UNITED STATES PATENT AND TRADEMARK OFFICE

Office Action Summary	Application No.	Applicant(s)
	10/623,803	KELLER, ARNOLD
	Examiner Anu Ramana	Art Unit 3733

DETAILED ACTION

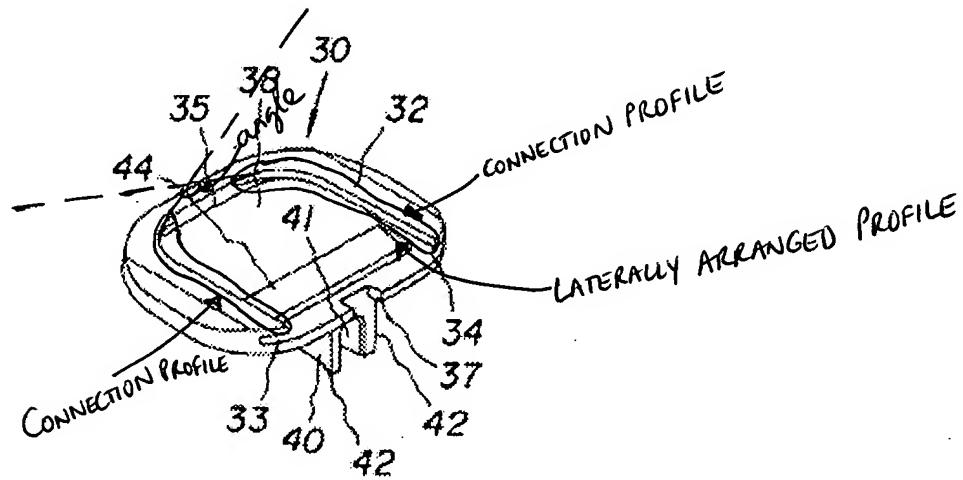
Marnay et al. disclose an intervertebral implant or prosthesis including two cover plates (11, 30) and a prosthesis core 50 wherein core 50 is connected to plate 30 by substantially straight undercut "connection profiles" that point generally inwardly or "are arranged" at an angle to one another wherein the angle is clearly not obtuse (Figs. 10, 11 and 13 and paras [0041] – [052]). See marked up Figure 10 on the following page.

Regarding claims 3 and 4, Marnay et al. disclose an engaging structure 44 arranged on a ventral side of the prosthesis having a pair of laterally arranged profile sections (see marked up Fig. 10 below).

Marnay et al. clearly disclose a pair of undercut substantially straight profile sections symmetric about an anterior-posterior direction wherein the profile sections are arranged at an angle to one another as discussed above. It is noted that "substantially straight" does not imply that the profile sections are completely straight. The recitation "an angle to one another" does not exclude a zero angle. Further, the reference axes for measurement of the recited "angle" is not defined in claim 1.
